ACCESSION NBR: 8303230232 DOC. DATE: 83/03/15 NOTARIZED: NO DOCKET #  
 FACIL: 50-244 Robert Emmet Ginna Nuclear Plant, Unit 1, Rochester G 05000244  
 AUTH. NAME AUTHOR AFFILIATION  
 MAIER, J. E. Rochester Gas & Electric Corp.  
 RECIP. NAME RECIPIENT AFFILIATION  
 CRUTCHFIELD, D. Operating Reactors Branch 5

SUBJECT: Forwards response to 830311 request for info re mod to 1C  
 safety injection pump logic. Submittal consists of design  
 criteria & electrical schematics.

Subject: LC Safety Injection Pump Logic  
R. E. Ginna Nuclear Power Plant  
Docket No. 50-244

| ROCHESTER GAS & ELECTRIC CORP.<br>ROCHESTER, NEW YORK |          | GINNA 514<br>FIGURE I |                  |               |               |         |         |                 |  |

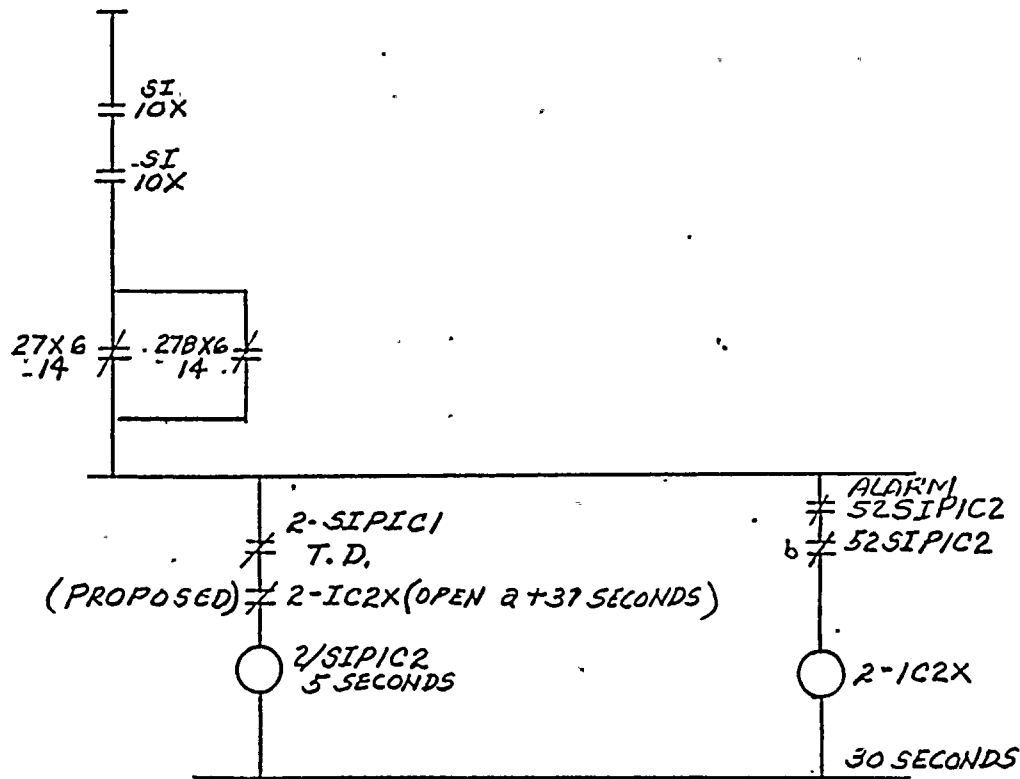
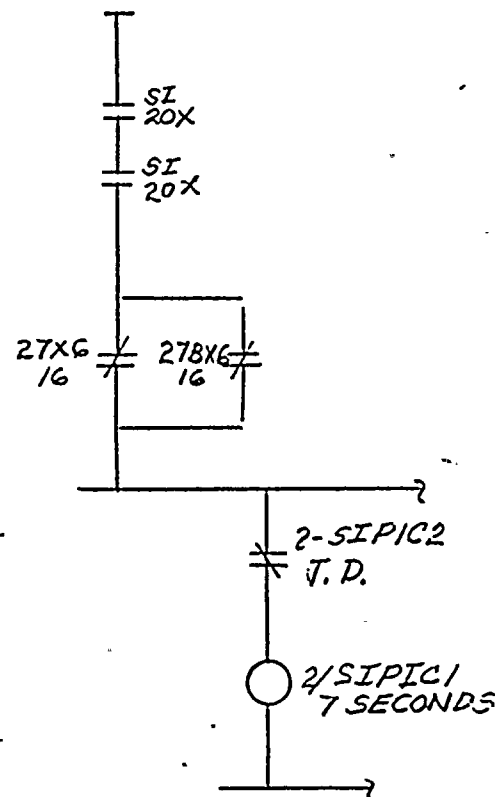
The first set of interlocks consists of instantaneous auxiliary contacts off of time delay relays associated with the 1C SIP breakers. This existing scheme is shown on Figure I. Normal operation of the 1C SIP system begins with a simultaneous SI signal and normal bus voltage. The timers on both systems initially energize, thereby simultaneously deenergizing each other, which through the interlocks, reenergize once again. This sequence occurs until such time as one interlock drops out ahead of the other and thus one timer is locked out. This sequence of instantaneously "picking up" and "dropping out" has the potential of delaying the overall time in which the 1C SI pump finally is placed in service. In addition, the timing relays can be overstressed.

Because the existing configuration is interlocked ahead of the timing relays it results in the unpredictable loading of the 1C SI pump onto either bus 14 or 16.

An improvement in the performance of the ESFAS system can be accomplished by using "time delayed" contacts as interlocks, that is, output contacts on the time delay relays.

Figure II details this modification, which establishes bus 14 as the preferred source for the 1C SI pump and bus 16 as the backup source, should bus 14 be out of service.

The proposed interlocking contacts are time delayed. That is, they will not open until the relay timers have completed their respective preset delay time. It can be seen that the 1C2 timer is set at 5 seconds while the 1C1 timer is set at 7 seconds. Consequently, the time delayed contacts on the 1C2 timers will deenergize the 1C1 timer in 5 seconds, thus making bus 14 the preferred source for the 1C SI pump motor.

Figure II represents part of the proposed modification which will allow the 1C pump motor to swing to bus 16, should the 1C2 breaker fail to close on bus 14 after a total delay time of 37 seconds. This transfer will not however be allowed if an electrical fault occurs on the 1C motor. This transfer scheme will not subject both trains to a common electrical fault. This is an NRC requirement and must be included in this modification.

The proposed modification to the ESFAS system utilizes a spare TD relay on the A Train Sequencer. The new relay (2-1C2X) will be energized through a "b" contact off of the SIP breaker on bus 14 (52/SIP1C2) coincident with an alarm switch off of the same breaker.

The new timing relay will be set at 30 seconds and it follows the 2/SIP 1C2 timer until it times out and causes the 1C2 breaker to close. If this breaker fails to close within the 30 second period, then the 2-1C2X

will energize and drop out the 2-SIP1C2 timer and allow the 2-SIP1C1 timer to pick up and seven seconds later, the 1C pump will be automatically loaded on bus 16.

| ROCHESTER GAS & ELECTRIC CORP.<br>ROCHESTER, NEW YORK |          |                 | GINNATA STA<br>FIGURE III |               | SCALE<br>NO. EWR 3435 |                 |

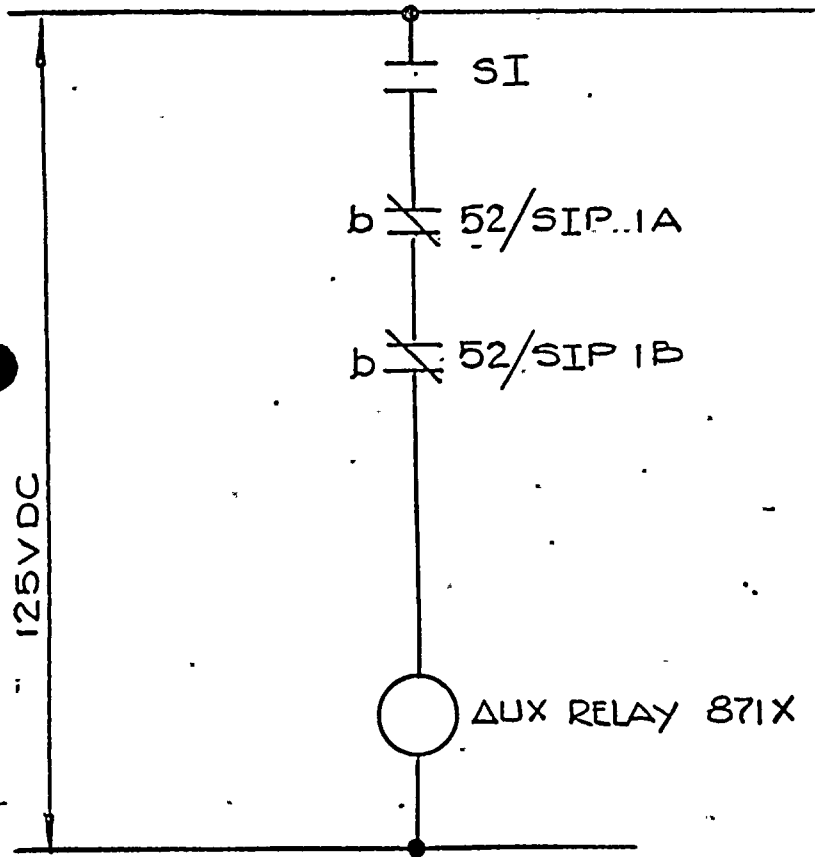
In the event that either the 1A or 1B SI pump breakers fail to close after an SI signal is received, then the 871 A or B valves are automatically aligned so that the 1C pump functionally replaces the lost SI pump.

However, in the event that both the 1A and 1B SI pump breakers electrically fail to close after an SI, the 871 A & B valves will automatically go closed, isolating the 1C pump.

The proposed modification will provide valve control logic consisting of an auxiliary relay that energizes only when both the SIP1A and 1B breakers fail to close. This relay will block the auto closure of both 871A & B valves. This logic is only formed during SI. The auxiliary relay, once energized, will prevent the 871 A&B valves from going closed. (Note: 871 A&B are normally "opened"). Figure III outlines the proposed scheme.
